**BLOOMINGTON PLAN COMMISSION
STAFF REPORT
Location: 1825 S. Covey Lane**

**CASE #: DP-24-19
DATE: July 8, 2019**

REQUEST: The petitioner is requesting preliminary plat approval of a 3-lot subdivision of 0.72 acres.

**SITE PLAN OF PROPOSED LOTS 80A, 80B AND 81A IN
HUNTINGTON PARK SUBDIVISION PRELIMINARY PLAT
THE WEST HALF OF LOTS 80 & 81 IN HUNTINGTON PARK SUBDIVISION,
AN ADDITION TO THE CITY OF BLOOMINGTON, MONROE COUNTY, INDIANA**

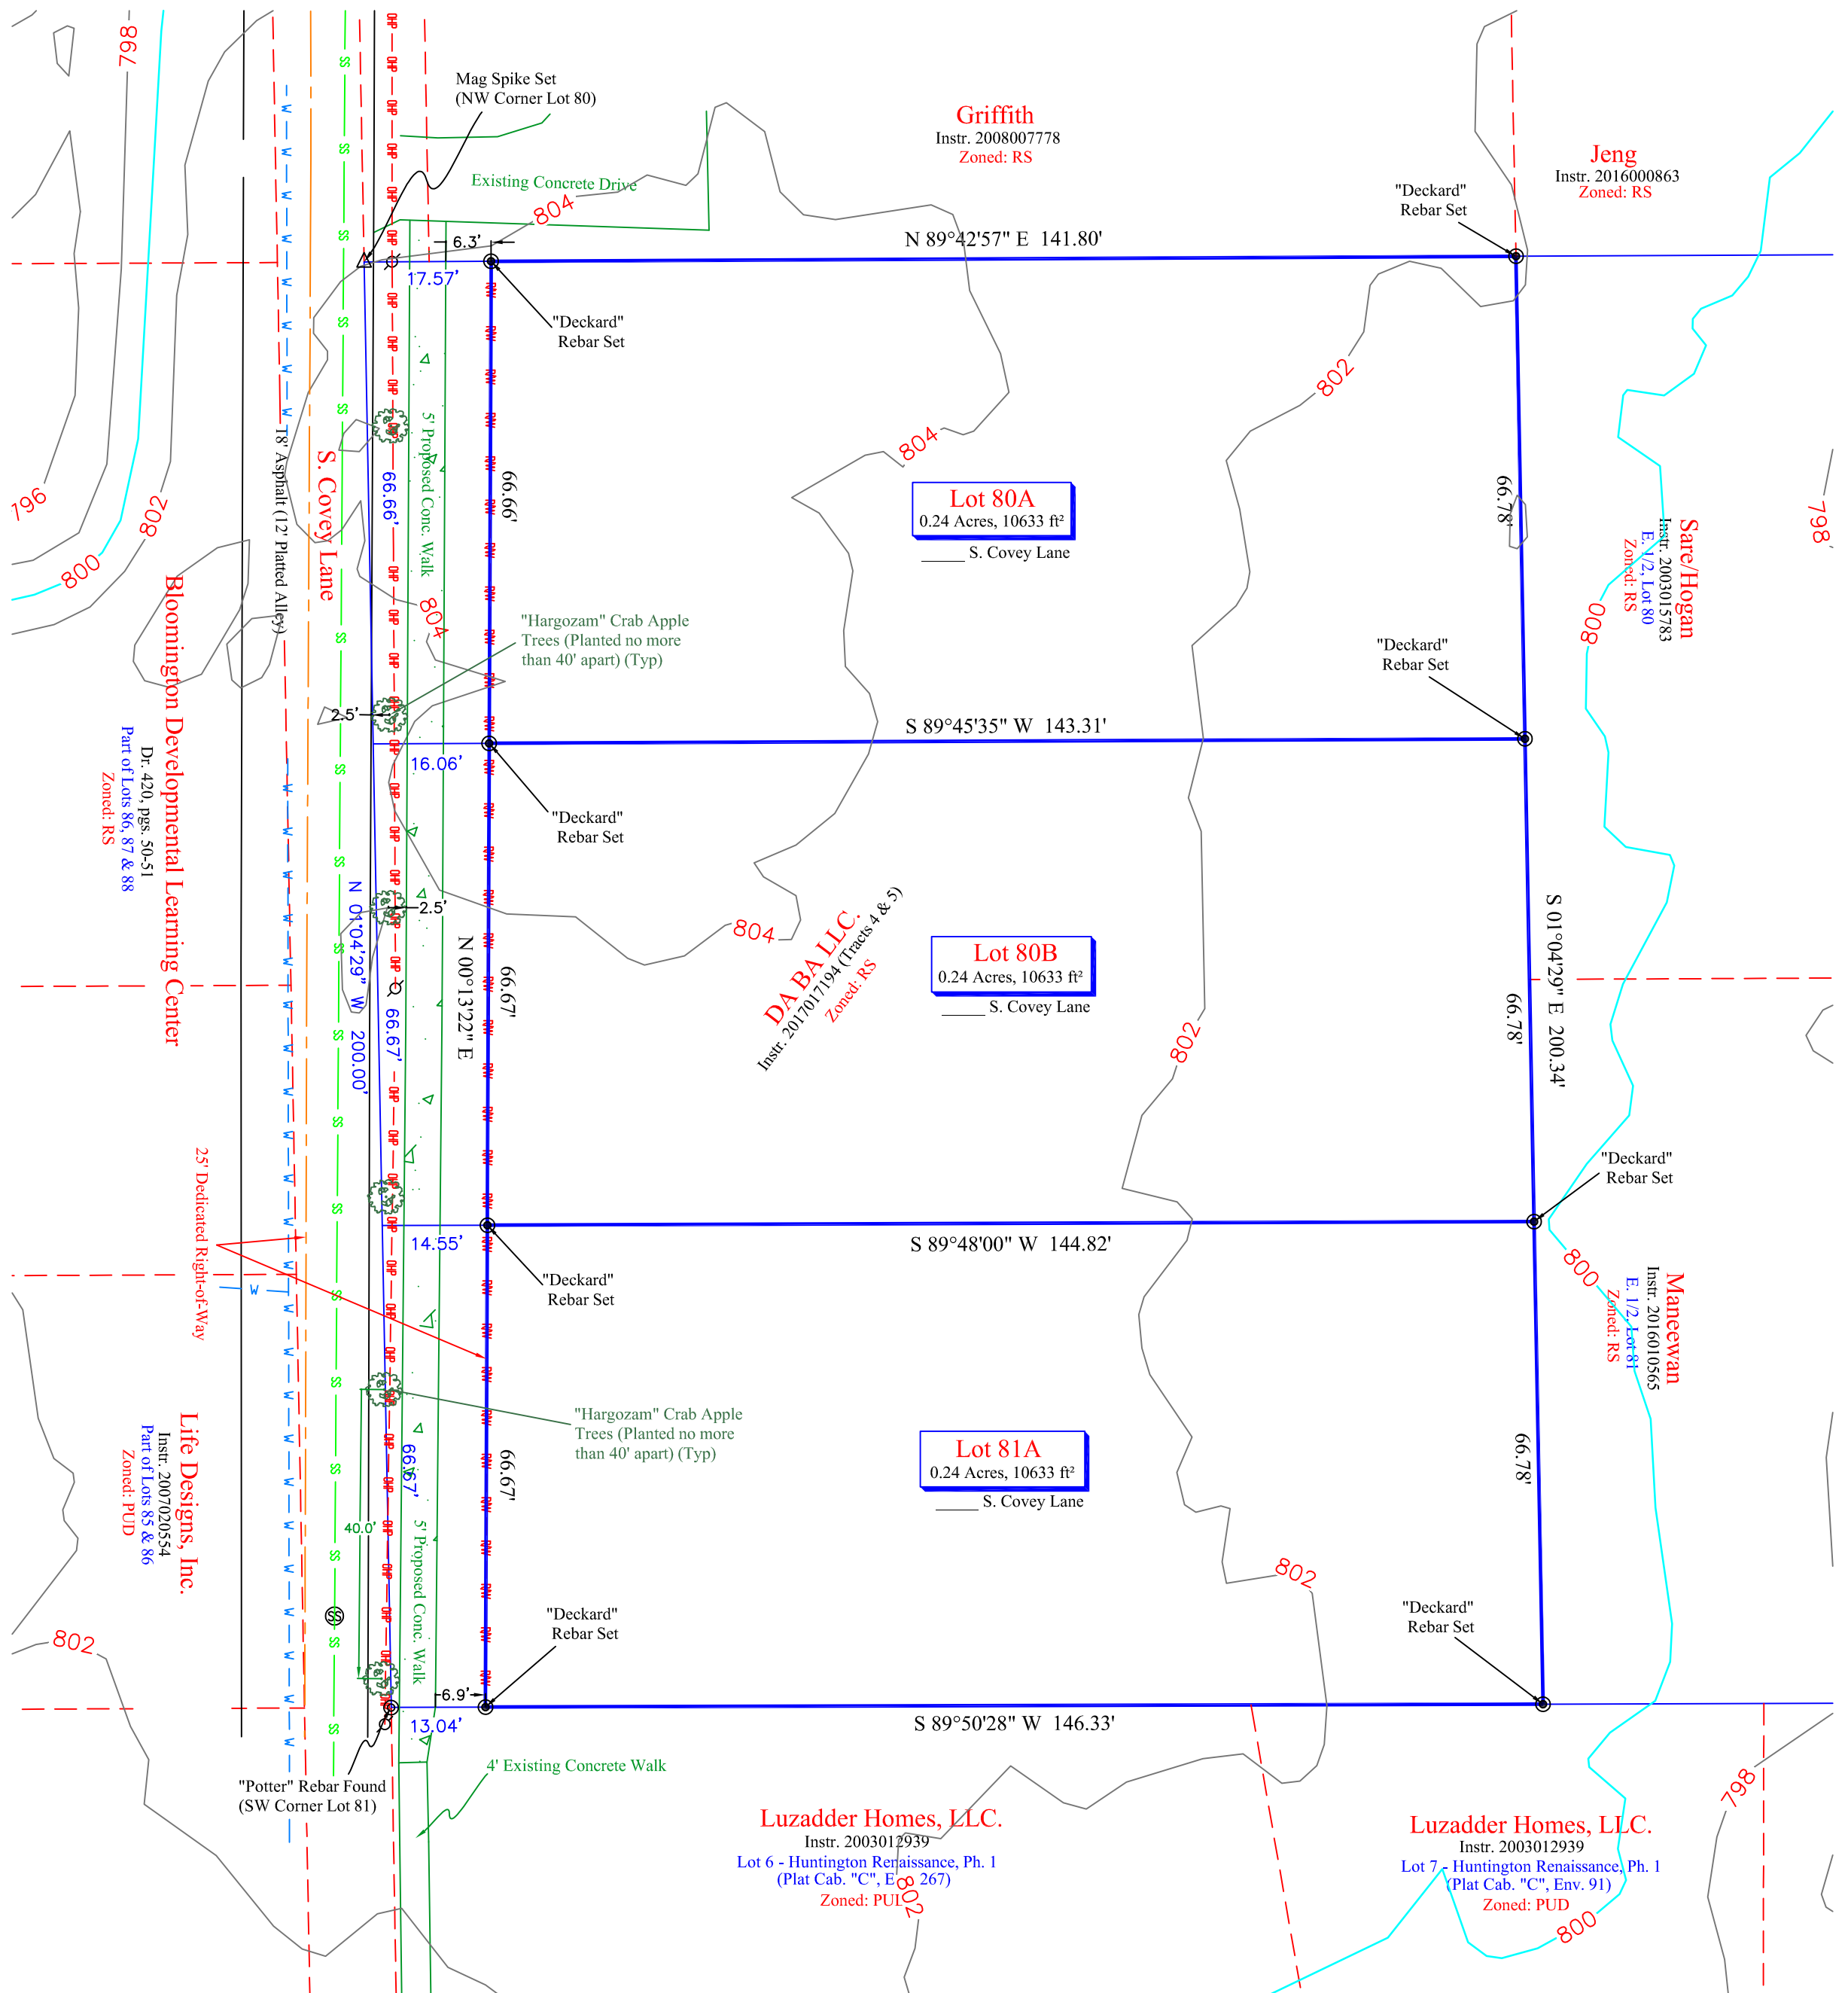
Right-of-Way Dedication: The petitioner is required to dedicate right-of-way for Covey Lane and this has been shown on the preliminary plat. A total of 25' of right-of-way dedication is required from the centerline. Street trees not more than 40' on center. These must be installed or bonded for prior to signature of the final plat.

Pedestrian Facilities/Alternative Transportation: With this subdivision request the petitioner is required to install a 5' wide concrete sidewalk that is separated from the street with at least a 5' wide tree plot. The sidewalk and street trees must be installed or bonded for with the final plat signature. Street tree species are to be coordinated with the City Urban Forester.

RECOMMENDATION: Based on the proposed findings, the Department recommends approval of this subdivision request with the following conditions:

1. A 5' wide concrete sidewalk and at least a 5' wide tree plot and street trees not more than 40' from center are required within the right-of-way.
2. The addresses for each lot must be shown on the final plat.
3. The location of the sidewalk must be adjusted to be 1' within the right-of-way line.
